Central Precinct Renewal Program

Noise and Vibration Assessment Addendum Report

August 2023

Figure 2: Revised Urban Design Framework

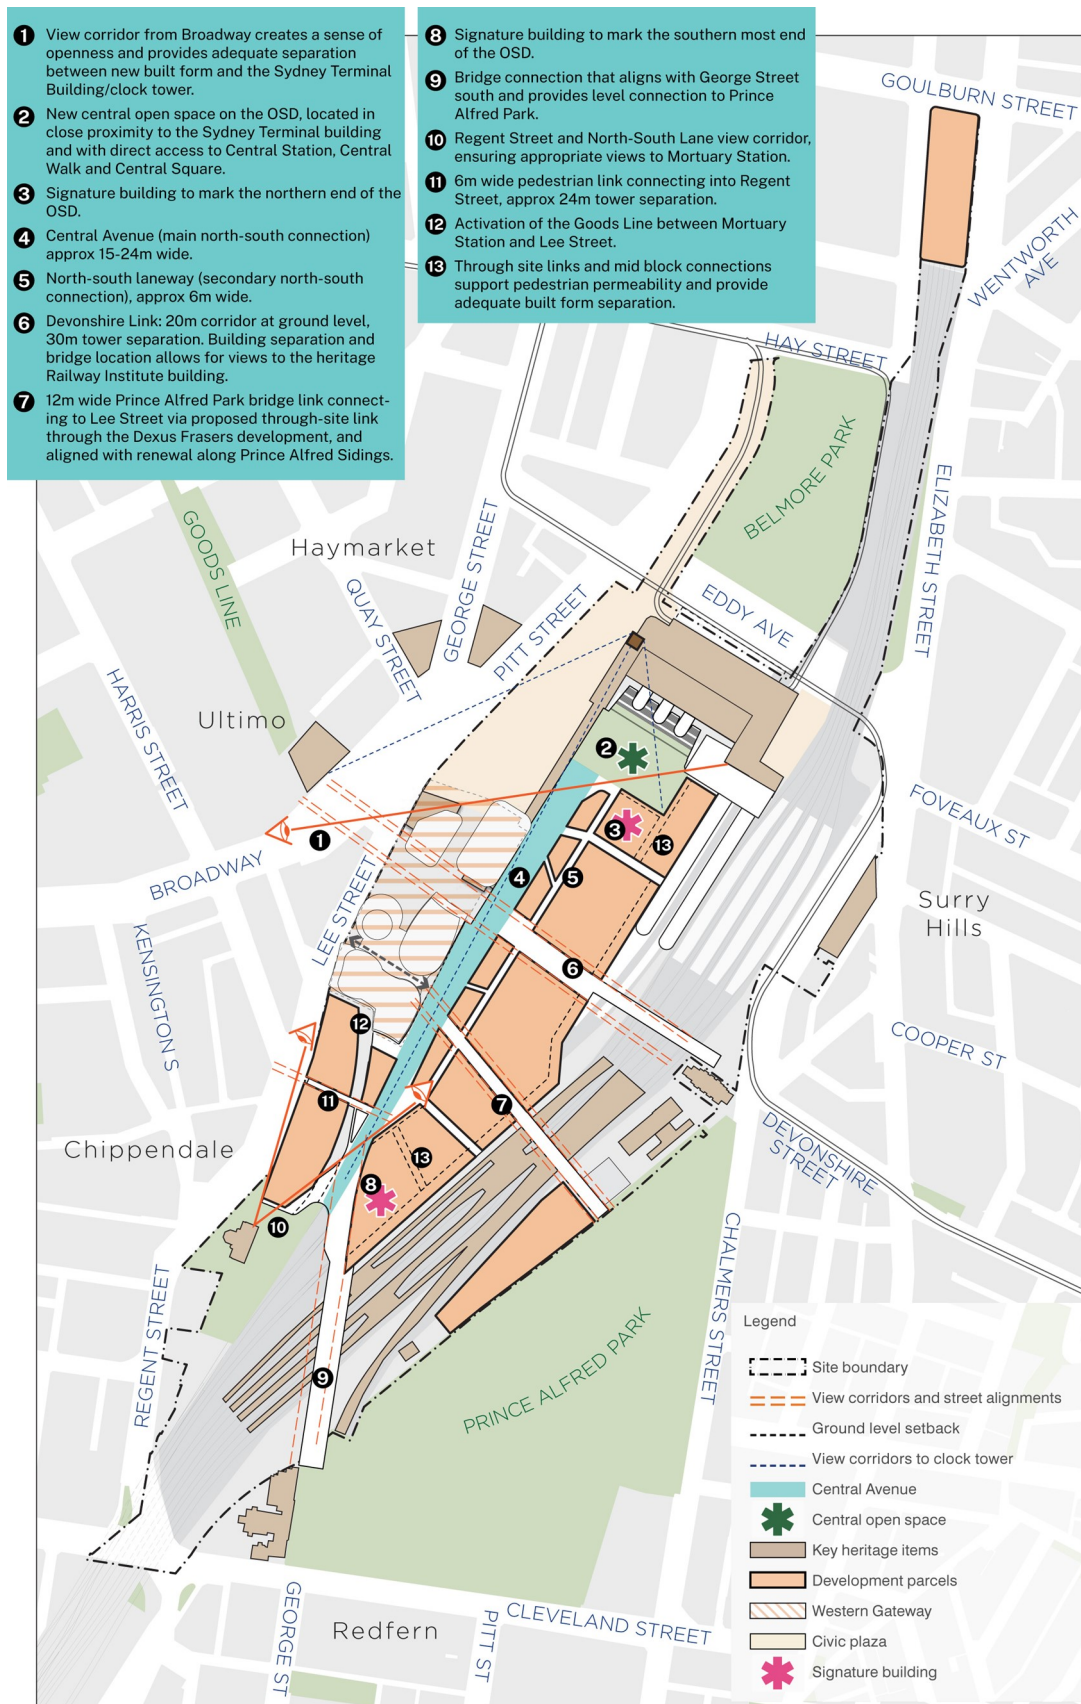
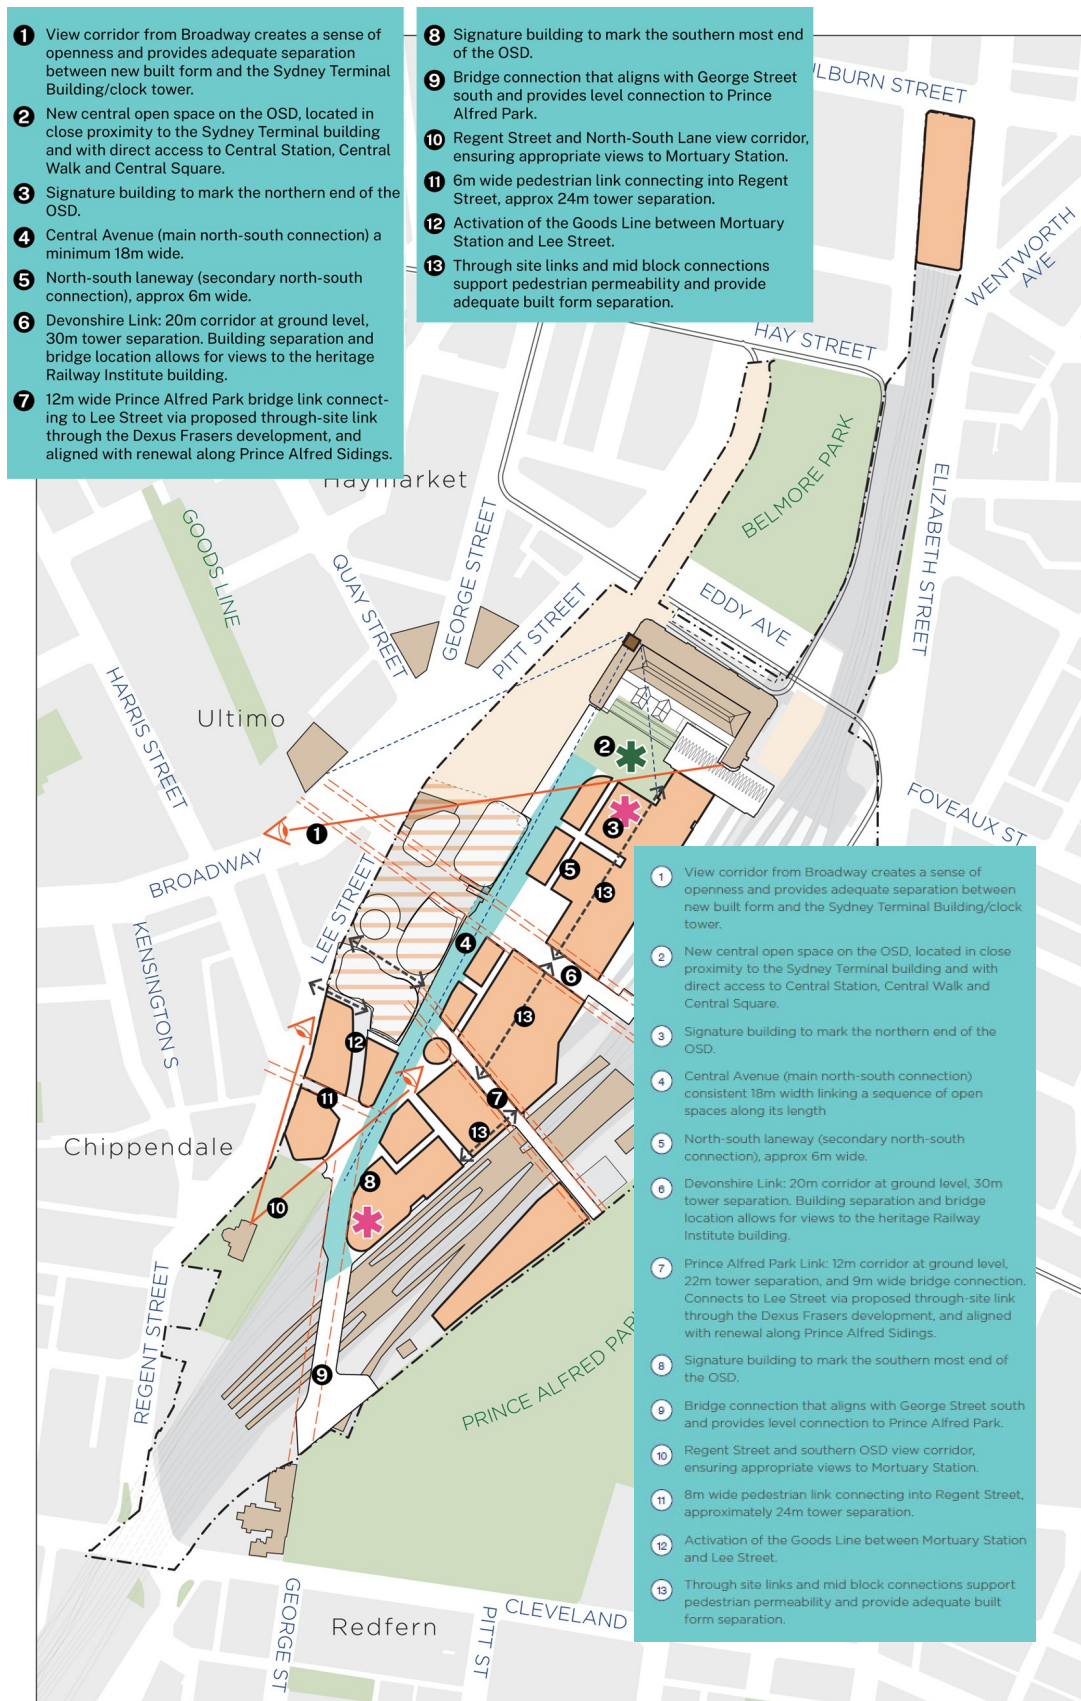
The feedback on the exhibited rezoning proposal has informed subsequent amendments to the Reference Masterplan. A summary of the key changes adopted as part of the revised Reference Masterplan are described below:

- **Improved interface between Terminal and OSD:** The interface relationship between the OSD deck and the Terminal Building has been further rationalised to improve the function of the station as a major interchange and better respect the heritage of Central Railway Station. The following changes have been made:

- a reduced spatial extent of the stairs between the OSD deck and the Terminal to now be a consolidated vertical connection (stairs, lift and escalators) to the north-eastern edge of Central Green

- an expanded concourse level with greater access to daylight and new opportunities for landscaping that will improve the passenger experience on the platforms and in the concourse, compared to the exhibited proposal

- incorporating an interpretation of the platform canopies to deliver a heritage-responsive and weather-protected connection.
- **Consistent 18-metre-wide Central Avenue:** A consistent width of 18 metres has been provided for Central Avenue. The future role and function of this link has been revised from an avenue between the north and south of the OSD deck to now becoming a connector of a sequence of public spaces on the OSD deck.

- **Additional mid-block through-site links:** The introduction of additional mid-block connections to reinforce breaking up the podiums on the OSD deck level into interconnected smaller building forms.

- **Removal of the Eastern Colonnade:** The eastern colonnade has been removed from the revised Reference Masterplan.

- **Reconfiguration of Central Green:** The layout of Central Green has been adjusted to be a squarer geometry compared to the exhibited proposal. The primary movement path through Central Green is now focused toward the southern and eastern edges of this open space. The indicative design of Central Green has also been adjusted to improve its relationship with the Terminal Building through the incorporation of seating and greater landscaping at the northern edge of the park.

- **An enlarged Mortuary Station Gardens:** The reduction of the podium building envelope of the Regent Street Sidings building brought about through changes to the bus layover and basement entry /exit pathways provide for an enlarged public space at Mortuary Station Gardens by 2,030 square metres to a total area of 6,500 square metres. The increase in the size of this public space also presents the opportunity to retain the existing fig tree at Mortuary Station and provide a new playground that is accessible to the broader community.

- **Devonshire Square:** A new square of approximately 3,700 square metres has been included into the revised Reference masterplan at the junction of Central Avenue and the Devonshire link, which will provide a new civic space at the entry point to the proposed extended Central Walk. (Central Walk will provide access to all of the rail platforms in Central).

- **Southern Plaza:** A new reconfigured civic space of approximately 4,700 square metres at the southern end of Central Avenue, providing a new arrival and meeting space when coming from the south. Within the Southern Plaza, there is the potential for a marker building that is designed with a Connecting with Country focus.

- **Regent Street Sidings:** The podium envelope at Regent Street Sidings has been further rationalised to improve the integration between the OSD deck level and Regent Street Sidings, the Goods Line and Mortuary Station Gardens. This has been through the following changes:

Figure 1: 3D View of Updated 3D Noise Model

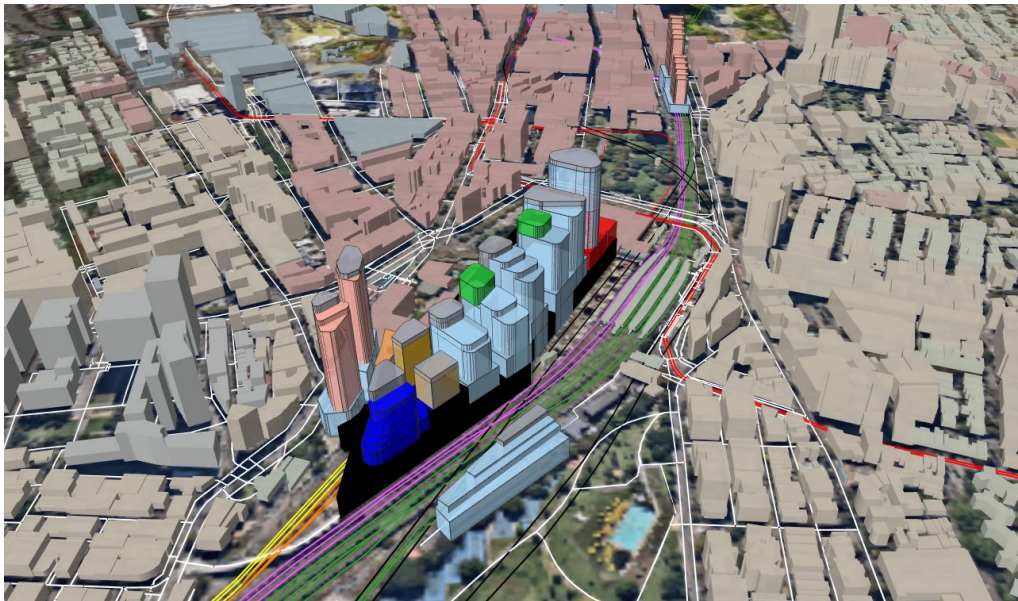
To assess the revised Reference Master Plan the 3-dimensional noise model has been updated to reflect the built form as provided in the building massing provided 03/05/2023 as shown below in Figure 1.

Changes in noise impacts caused by the updated massing in the revised Reference Master Plan were assessed for noise generated by external noise sources (primarily road and rail) and mechanical plant noise.

Predicted façade noise levels were reviewed. Changes in noise levels were generally minor meaning that building controls and mitigation measures detailed in the SSP Noise and Vibration Assessment Section 9.1 remain unchanged.
